**ARCHITECTURAL REVIEW BOARD
MUNICIPAL PLANNING COMMISSION
-AGENDA-
Thursday, October 13, 2016 at 7:00 P.M.**

MEMORANDUM

SUBJECT: Staff Memo for the Meeting of October 13, 2016

BUILDING 'B'

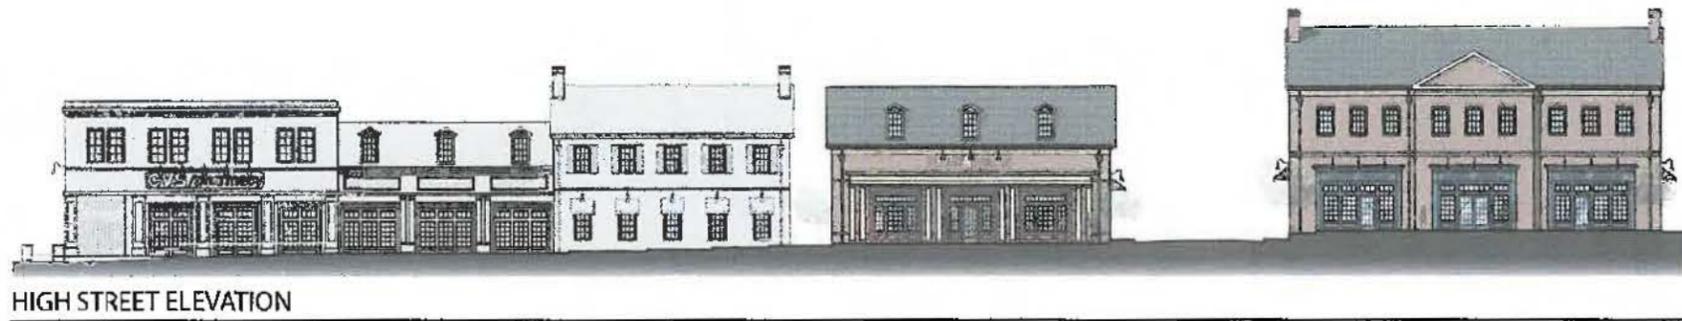
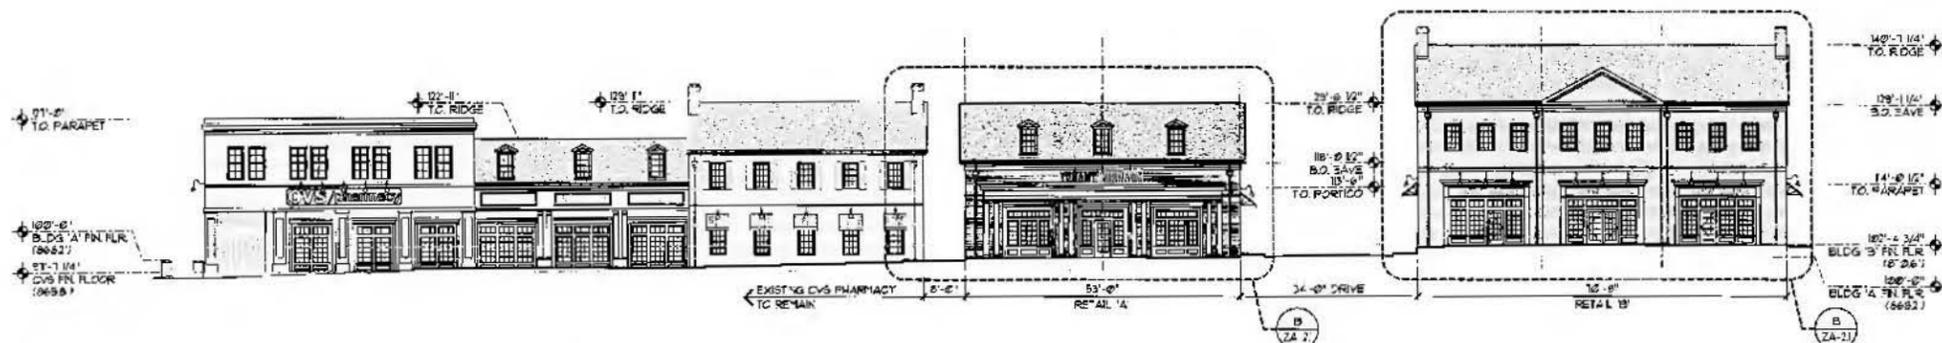
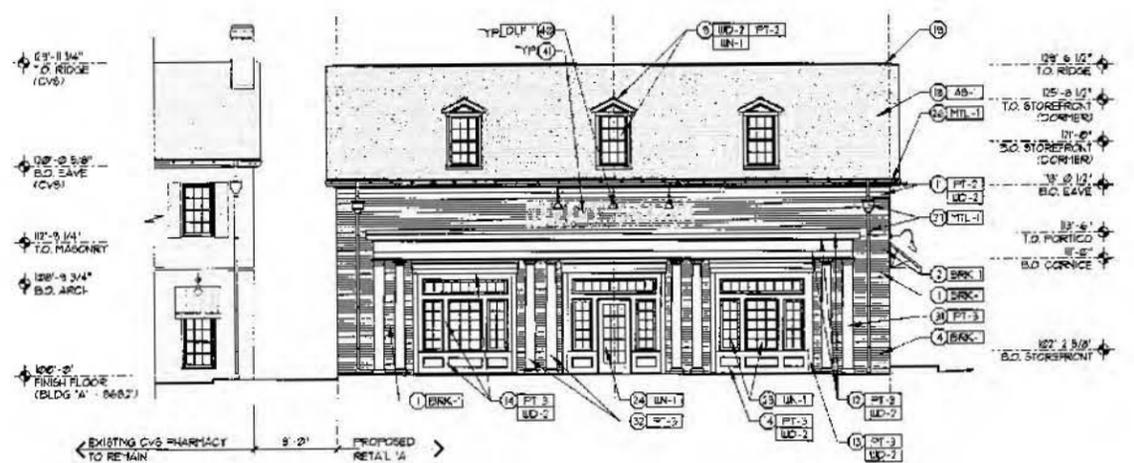
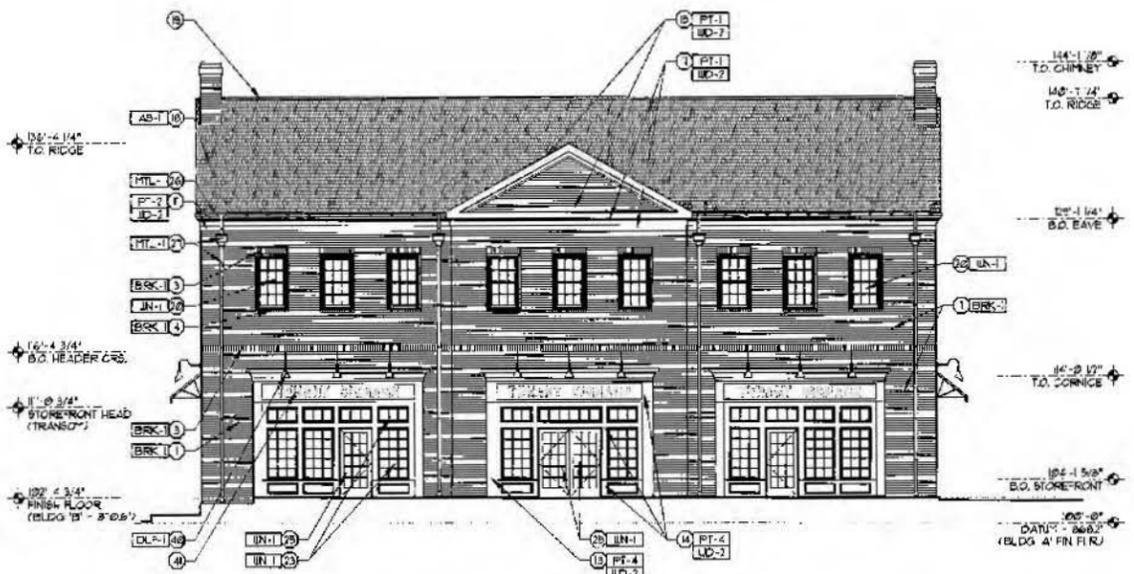
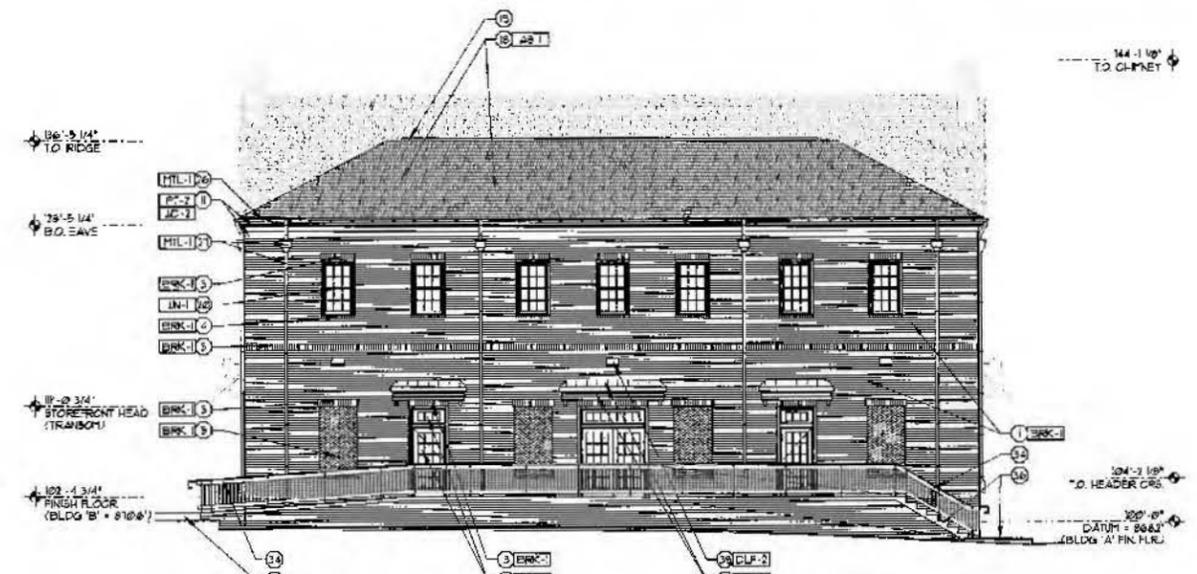
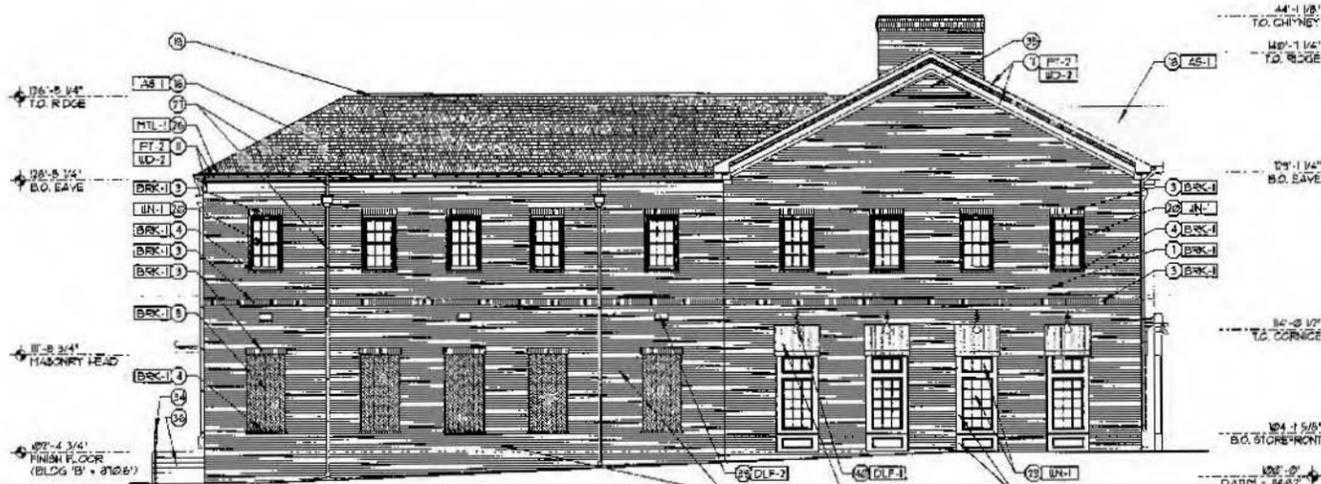
Building “B” is proposed to be a full two story brick building with 6402 sf of area per floor. The first floor would likely be retail or restaurant, with the second floor being office space. Like “A”, “B” would have a gable across the front part of the building, but would then have a hipped roof extending to the rear. Two chimneys are proposed at the ends of the front gable. The first floor could accommodate 1-3 tenants, and would have 3 storefront elements across the front. The center element is proposed with a gable above and extends out further than the sides. The side elevations show columns framing the center, but the front elevation and renderings do not. Clarification is needed.

The storefront windows would have wood trim with sign bands above. Three double-hung windows are proposed for the second floor centered on each of the storefronts. The sides would have 9 over 6 double hung windows with transoms, brick soldier courses, awnings and lights above at the front, and herringbone patterned brick accent panels with a soldier course above to the rear. On the south elevation a double door is proposed that would provide access to the front stairs. The second floors would have nine 6 over 6 double hung windows lined up with the windows or brick panels below. At the rear, three doors would be accessed from a raised walkway with steps at one end and a ramp at the other end. The wall of the walk would be faced with brick to match the building. A small canopy with a standing seam metal roof is proposed above each entrance. The building is proposed with interior stairwells in the northeast and southwest corners of the building, and would have an elevator at the northeast corner.

Staff is recommending *approval* of this application. The site and building design are in character with the Design Guidelines and the previous Development Plan for this property. Demolition of an obsolete office building and the addition of new office space in Old Worthington is desirable.

N. HIGH STREET (U.S. ROUTE 23)

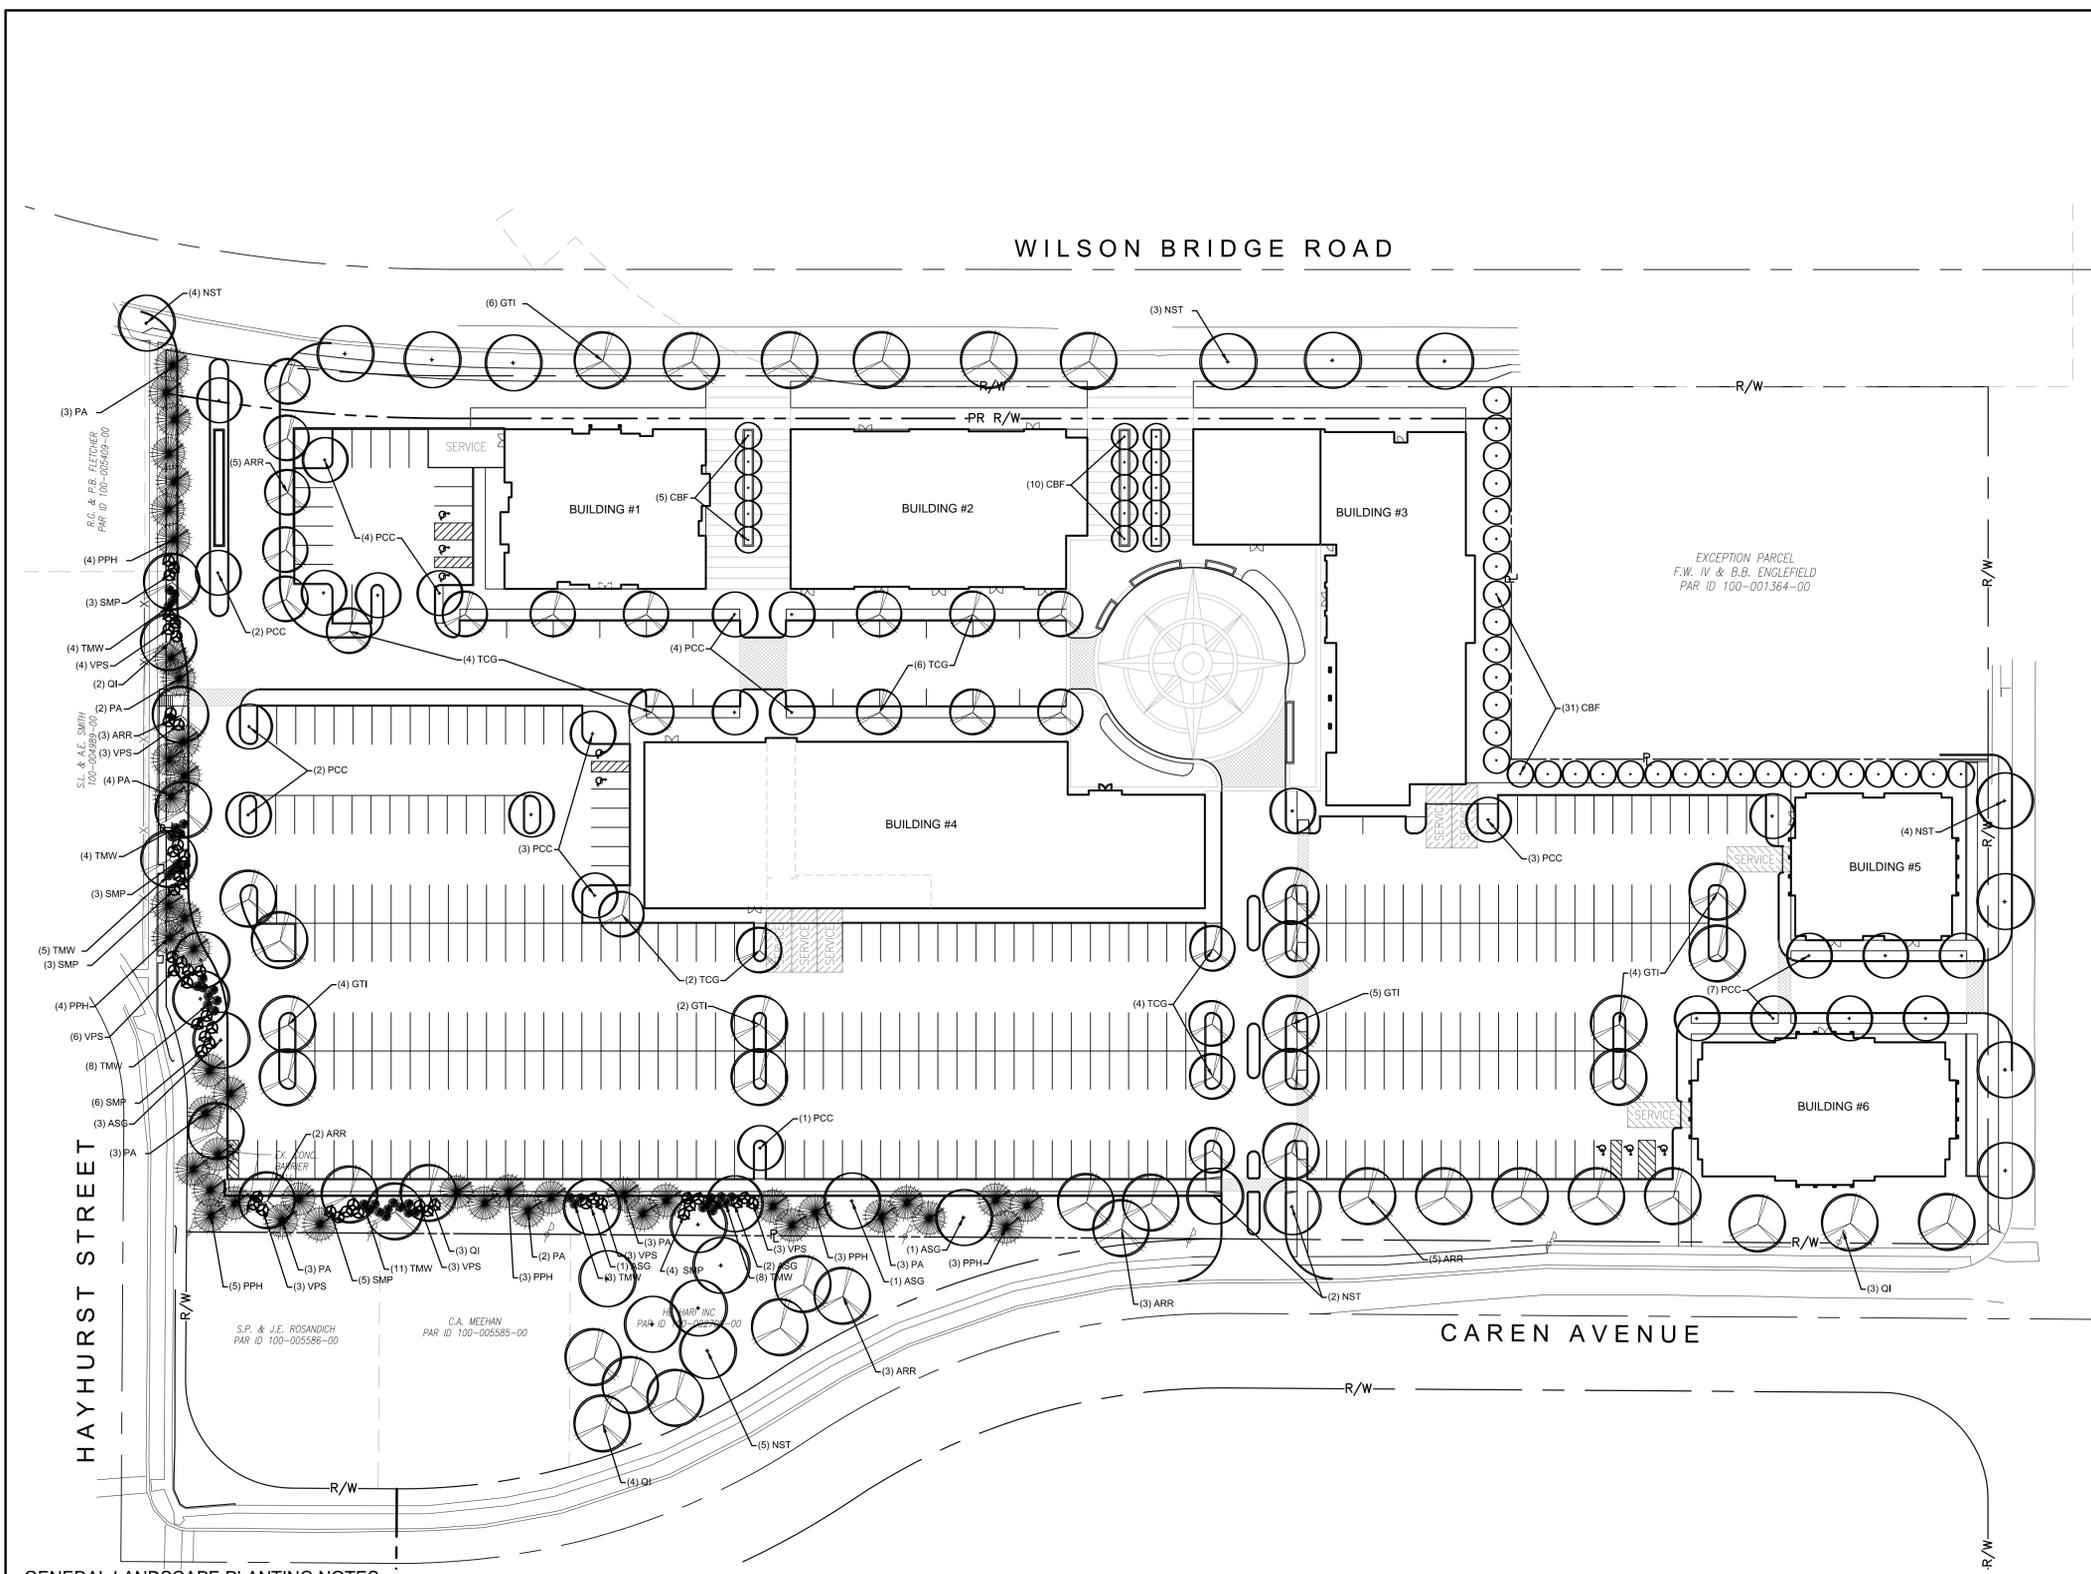
- *The proposed plan shows an entrance to the site from each of the adjacent rights-of-way. On W. Wilson Bridge Rd., the entrance is proposed at the west end; on Caren Ave. the proposed entrance is toward the middle of the site but on the eastern half; and on N. High St. the entrance is proposed near the middle of the site. All three entrances would be situated similarly to existing site entrances. Elimination of an entrance toward the east end of the site adjacent to W. Wilson Bridge Rd. is proposed.*

- *The buildings are laid out as in the last submission, concentrated to the north and east sides of the site.*
- *W. Wilson Bridge Rd. - Three building are proposed along W. Wilson Bridge Rd. about 36' from the roadway and 20' from the existing right-of-way line. The City has requested an additional 15' of right-of-way be dedicated, so the building would be 5' from the new line. In addition to the existing grass strip and sidewalk in the right-of-way, an area to plant street trees and sidewalk adjacent to the building are proposed. Two pedestrian access points would be provided between the buildings which would also allow for restaurant seating areas.*

- Stairs to the existing sidewalk west of the site are planned to allow pedestrian access for the residents.
- The remainder of the site would be surface parking with tree islands added. The applicant calculates 541 parking spaces would be required on the site based on the proposed uses, and 388 spaces are being provided. Should there be any times the site could not accommodate all of the guests, parking agreements with property owners to the south may be possible. Any parking agreements obtained would be subject to approval by the Board of Zoning Appeals with the variance request.

- *Consideration should be given to burying overhead utility lines at the south property line.*
- *A storm water plan will be required.*
- A preliminary traffic study has been submitted, but additional information will be needed to determine the viability of installation of a traffic signal at the W. Wilson Bridge Rd. entrance.

1. The proposed site and landscaping plans generally reflect the discussions at the ARB meetings, and are appropriate for the site.
2. Right-of-way vacation along both streets is still requested, but has only been shown along W. Wilson Bridge Rd.

4. Staff is recommending *tabling* of this application after discussion, to allow the applicant to make modifications and add detail based on the guidelines and any recommendations made at the meeting.
